LAND USE SERVICES DEPARTMENT
PLANNING COMMISSION STAFF REPORT

HEARING DATE: November 3, 2016 **AGENDA ITEM # 2**

Project Description: General Plan Renewable Energy and Conservation Element

Applicant:	Land Use Services Department
Community:	Countywide
Location:	Countywide
Staff:	Linda Mawby, Senior Planner
Proposal:	General Plan Amendment to incorporate a new Renewable Energy and Conservation Element.

Figure 7. Desert Tortoise TCA Linkage Conflicts in the Pinto Lucerne Valley Eastern Slopes

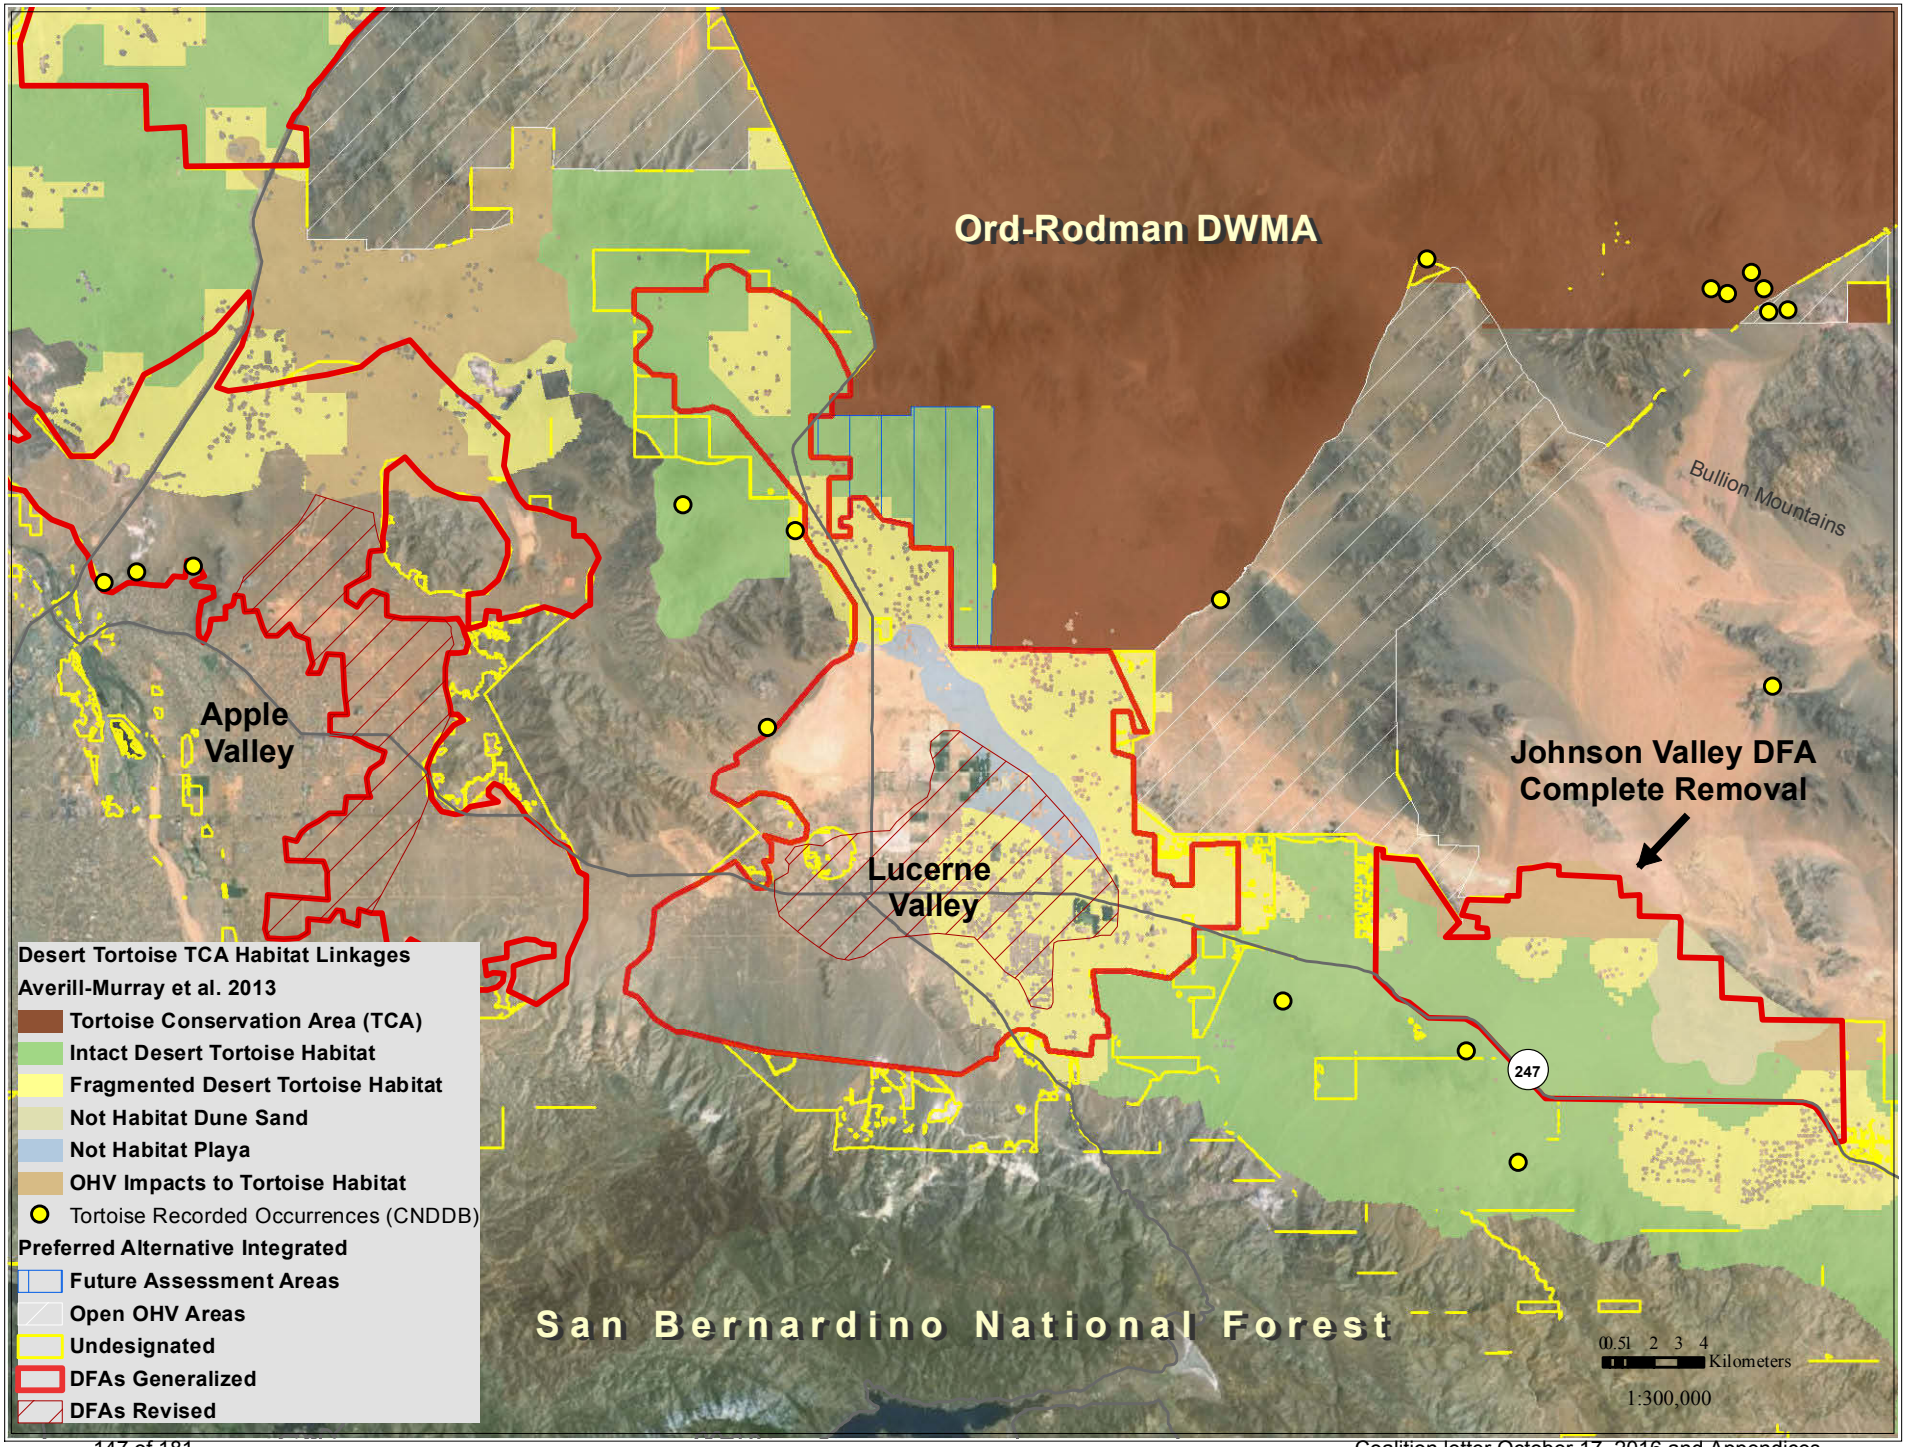
There are several areas where the Lucerne Valley and Johnson Valley DFAs conflict with two desert tortoise linkages in the Western Mojave Recovery Unit, Fremont-Kramer to Ord-Rodman Linkage and the Ord-Rodman to Joshua Tree linkage (Figure 7). The upper arm of the Lucerne Valley DFA coincides with intact desert tortoise habitat in the Fremont Kramer to Ord-Rodman Linkage and the FAA that is sandwiched between this DFA and the Ord-Rodman TCA is made up almost entirely of intact desert tortoise. This area of the Lucerne Valley DFA and the FAA is also in conflict with the Desert Linkage Network, Bighorn sheep intermountain habitat, and other Covered Species (e.g., Bendire's thrasher, burrowing owl, golden eagle). In addition, the Lucerne Valley DFA as currently proposed completely severs the northern segment of the Ord-Rodman to Joshua Tree Linkage and would severely compromise the function of this linkage (See AM-DFA-ICS-6 Comment). The great majority of the Johnson Valley DFA is also intact desert tortoise habitat that falls within the Ord-Rodman to Joshua Tree Linkage. These DFAs must be reconfigured to AVOID these Desert Tortoise Linkages.

The Johnson Valley DFA as currently proposed (Figures 7 and 8) would severely compromise the function of the Or-Rodman to Joshua Tree linkage. This proposed DFA is roughly 27,258 acres, much of it Intact Desert Tortoise Habitat as identified in Attachment B to Appendix D and Figures C-35 and C-36. The area of intact habitat in the linkage currently ranges in width from roughly 5 to 8 miles wide. The proposed Johnson Valley DFA would reduce the width of the linkage to about 3 miles wide in this stretch of the linkage. The average home range size for desert tortoise in the Western Mojave Recovery Unit is 125 acres (USFWS 1994, Boarman 2002). Would this significant reduction of intact habitat allow for "the maintenance of long-term viable desert tortoise populations within the affected linkage (AM-DFA-ICS-6)"? This entire DFA is identified as highly suitable in the desert tortoise Maxent model (Nussear et al.2009) and the great majority of it is BLM land. This linkage must not be written off, especially since one of the overarching Biological Goals is to, "Preserve, restore, and enhance natural communities and ecosystems including those that support Covered Species within the Plan Area". We recommend complete removal of this DFA to avoid this linkage in order to "maintain functional linkages between Tortoise Conservation Areas to provide for long-term genetic exchange, demographic stability, and population viability within Tortoise Conservation Areas" and meet the intent of Goal DETO2 (Desert Tortoise Linkages).

Figure 8. Desert Tortoise Ord-Rodman to Joshua Tree Linkage Conflicts

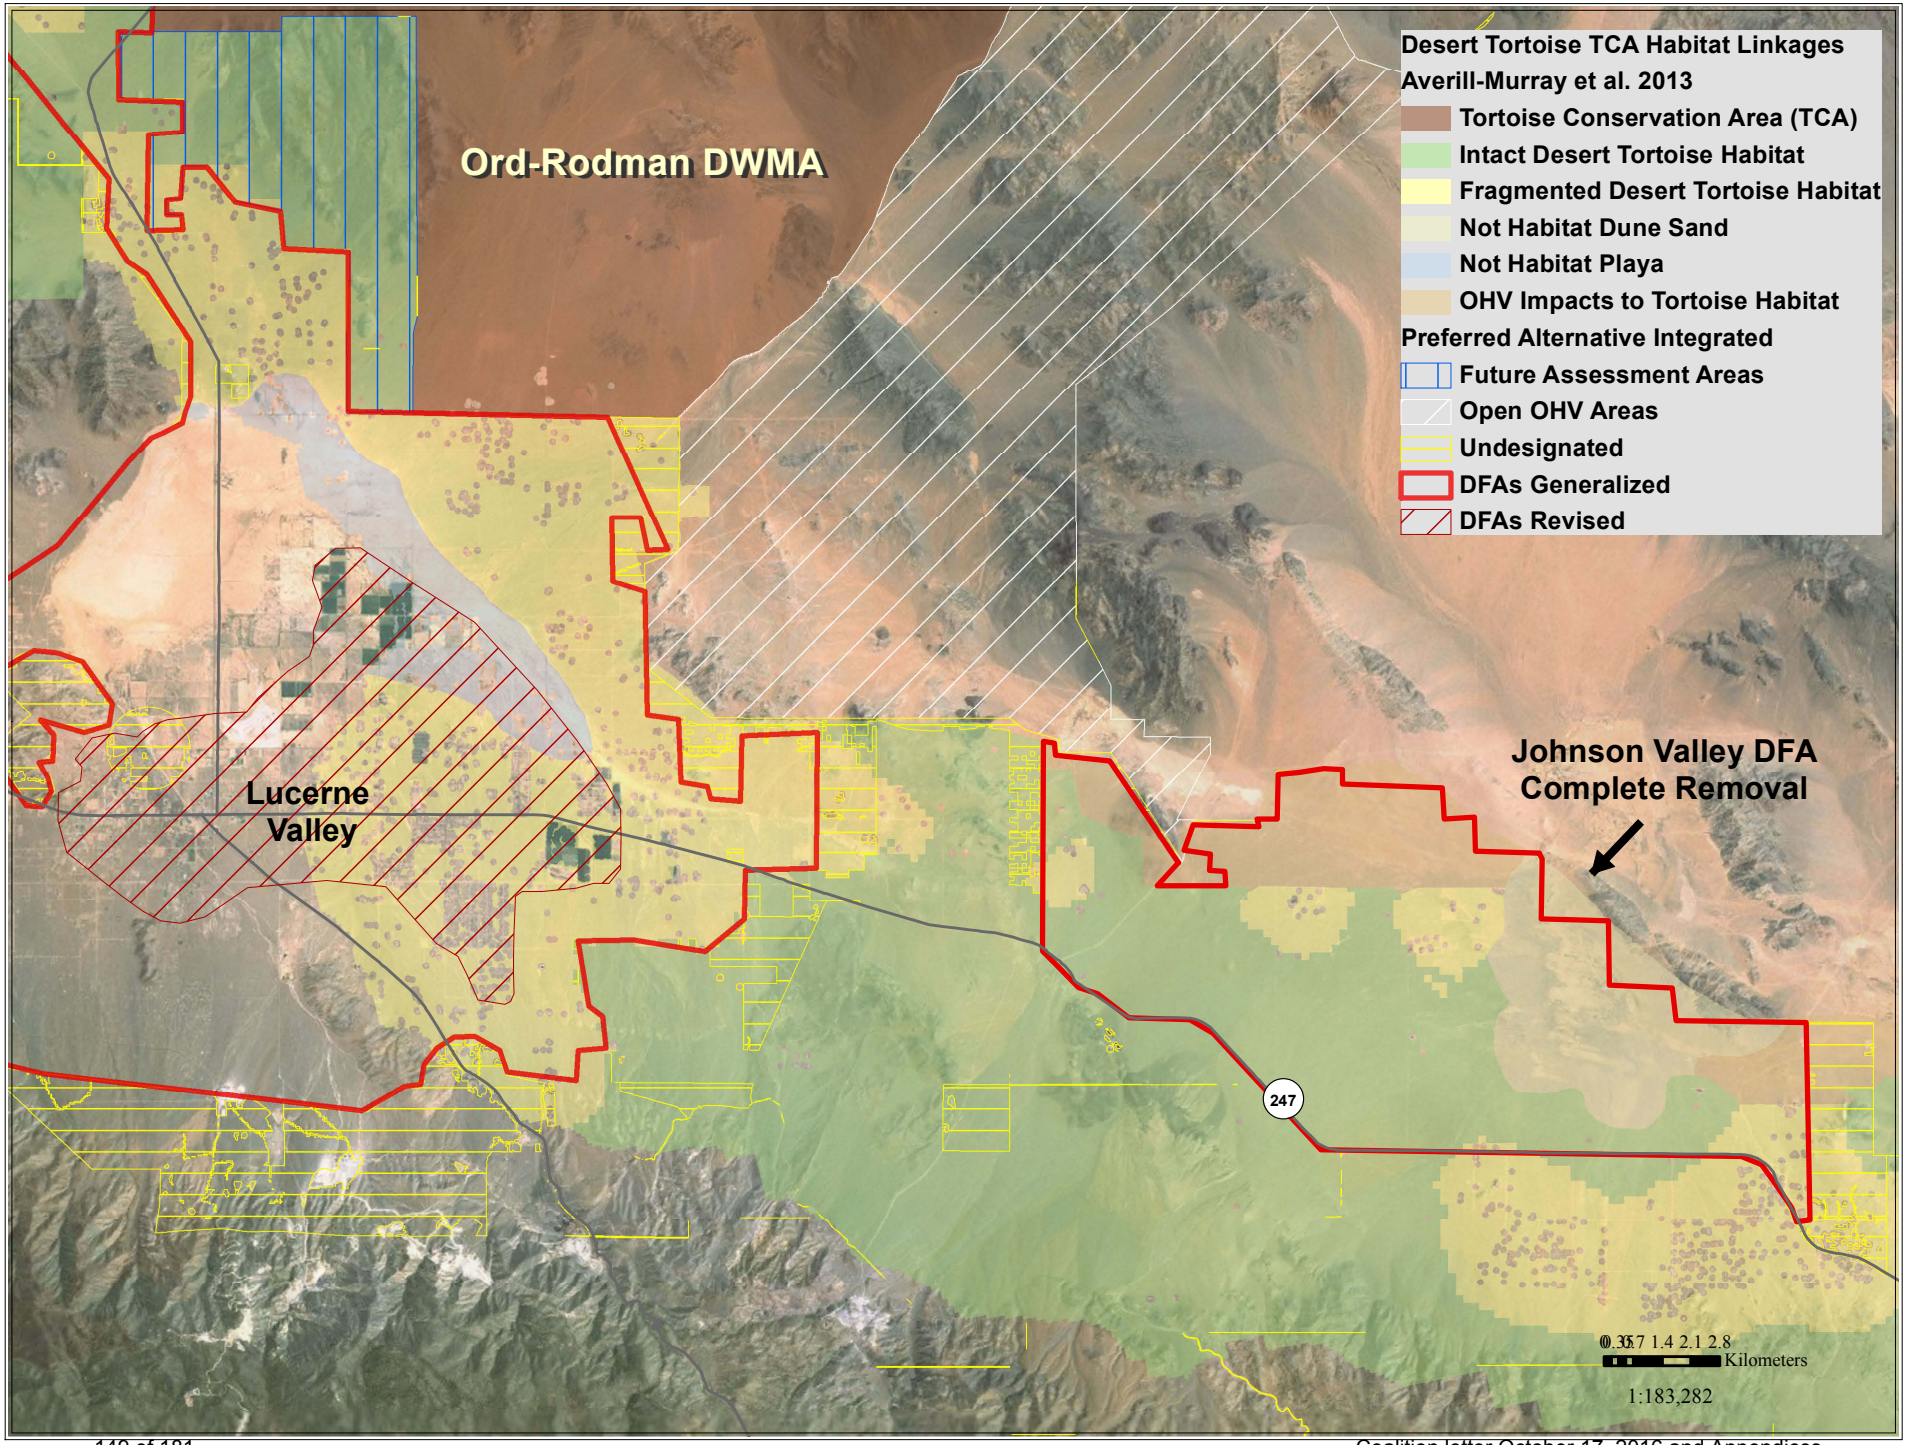
The Lucerne Valley DFA as currently proposed completely severs the northern segment of the Ord-Rodman to Joshua Tree Linkage (Figure 8) and would severely compromise the function of this linkage (AM-DFA-ICS-6). The analyses conducted by USFWS (Averill-Murray et al. 2013) indicate that this area is relatively permeable to tortoise movement and this entire area is identified as highly suitable in the desert tortoise Maxent model (Nussear et al.2009). This area of the linkage is identified as Fragmented Desert Tortoise Habitat in Attachment B to Appendix D but an evaluation of aerial imagery in this area reveals that existing rural development here is relatively sparse and the majority of residential properties in this area are unfenced. This area of the linkage should not be written off, especially since one of the overarching Biological Goals is to, "Preserve, restore, and enhance natural communities and ecosystems including those that support Covered Species within the Plan Area". The distance between the Ord-Rodman TCA and the Intact Desert Tortoise Habitat in the Old Woman Springs Wildlife Linkage ACEC is roughly 7 miles, fully within the movement capability of an individual tortoise. Sazaki et al. (1995) estimated dispersal distance for pre-breeding male tortoises to be between 6.21-9.32 miles. This DFA must be reconfigured to completely avoid this linkage. Further, the playa habitat to the west of the tortoise linkage, although not tortoise habitat, could buffer the tortoise linkage from Covered Activities in the remaining DFA, while also providing habitat for other Covered Species (e.g., burrowing owl, pallid bat, Townsend's big-eared bat) .

Figure 9. Mohave Ground Squirrel Conflicts in the Pinto Lucerne Valley Eastern Slopes

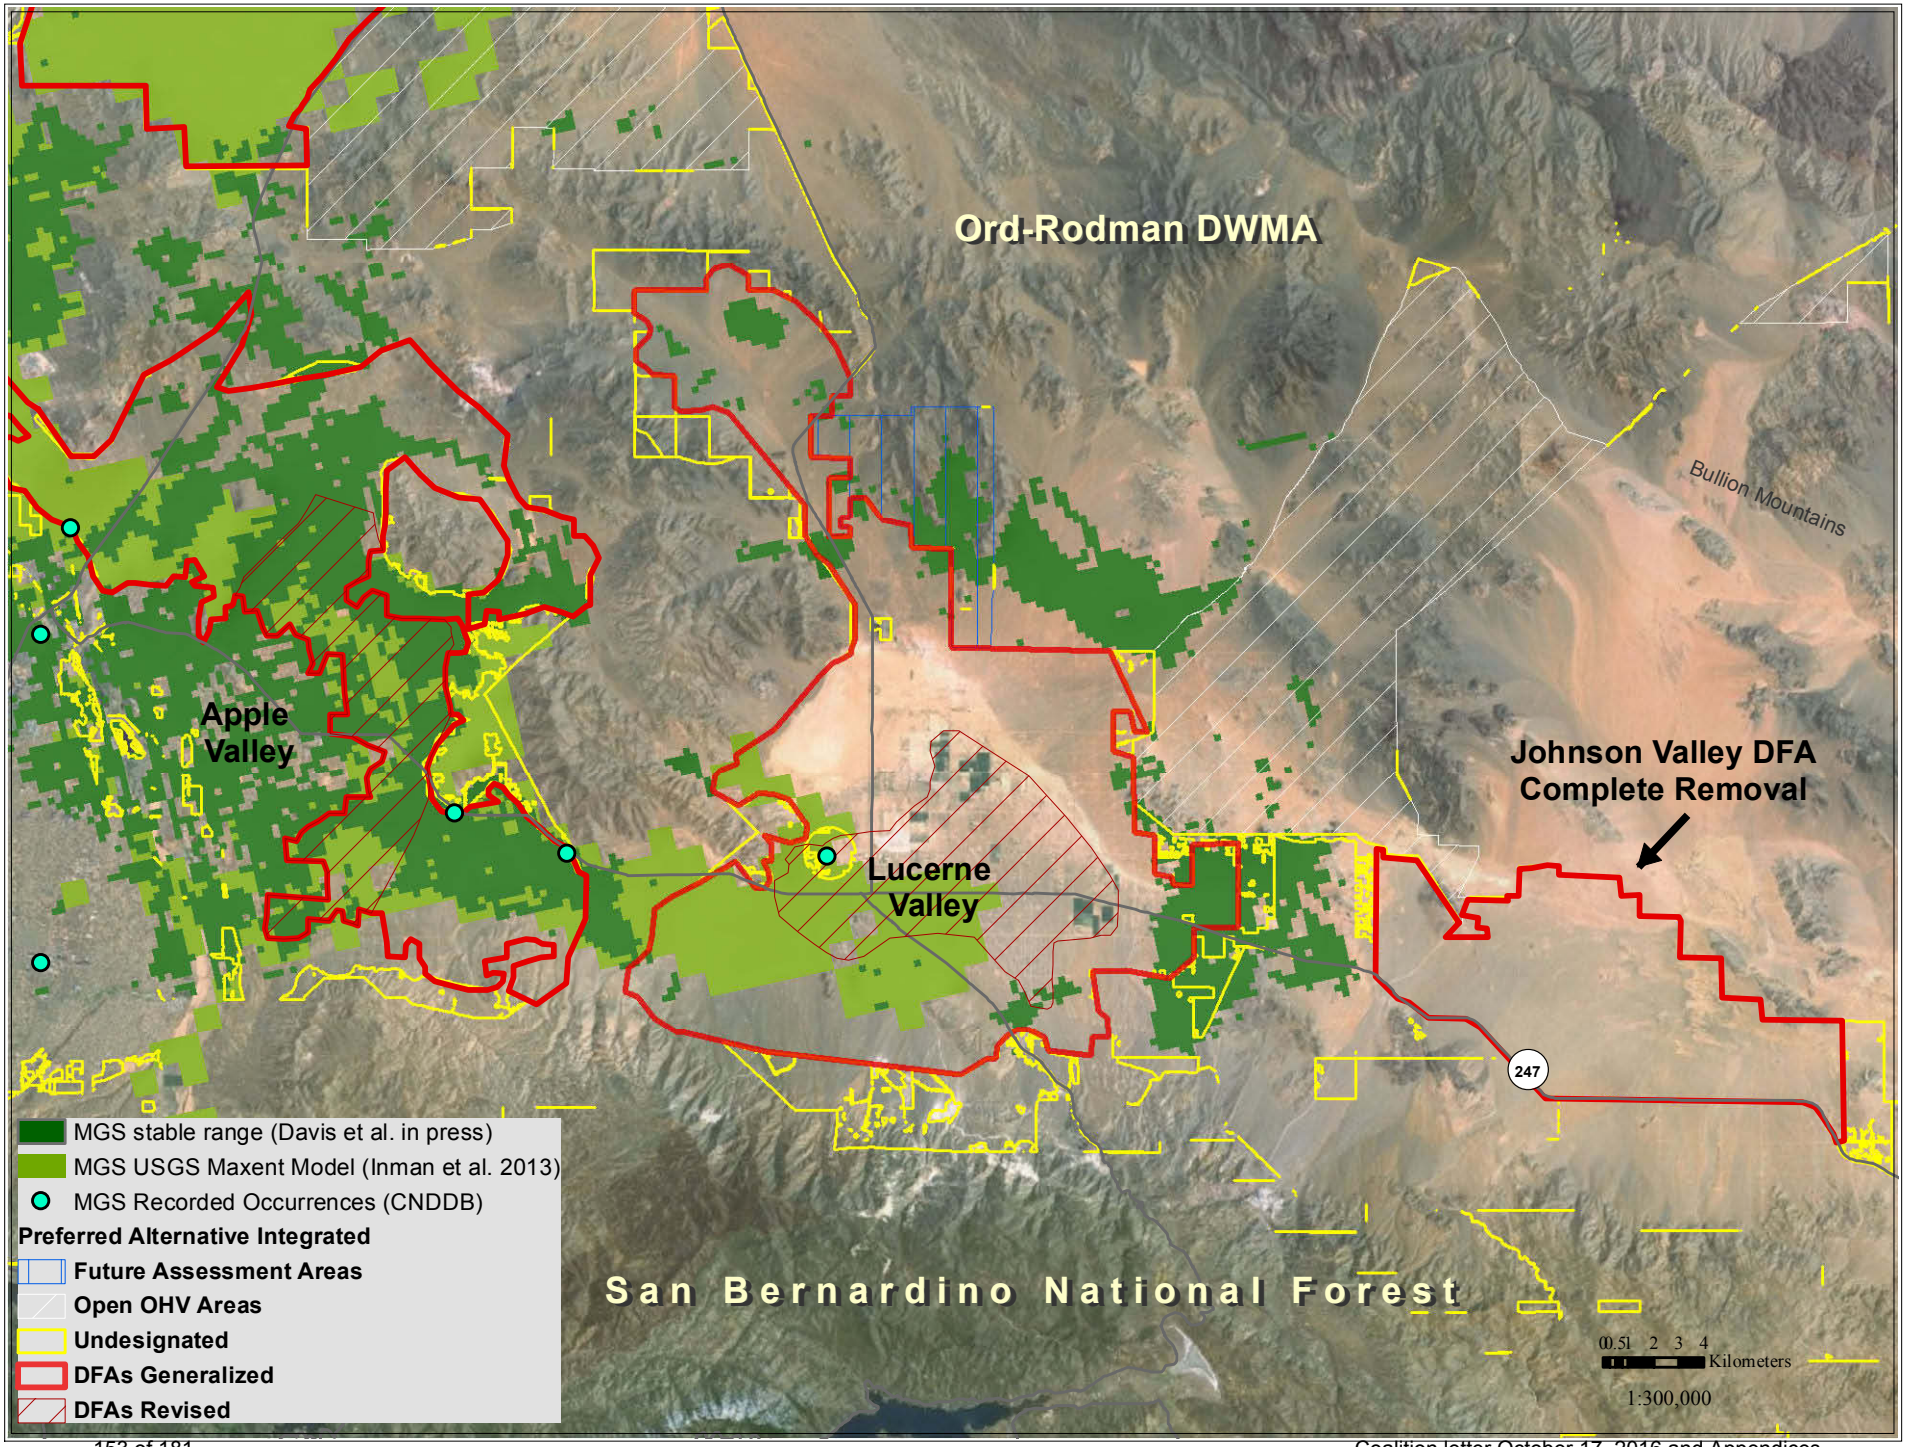
Figure 9 shows areas of the Apple and Lucerne Valley DFAs that conflict with the Mohave ground squirrel. While the Pinto Lucerne Valley and Eastern Slopes Subarea is outside of the Mohave Ground Squirrel Conservation Area, there are historical recorded occurrences in this subarea and specifically in the Apple Valley and Lucerne Valley DFAs. This subarea lies at the southernmost extent of this species distributional range (Inman et al. 2013) and several areas in this subregion are expected to remain relatively stable (Davis et al. in press) under an uncertain climate.
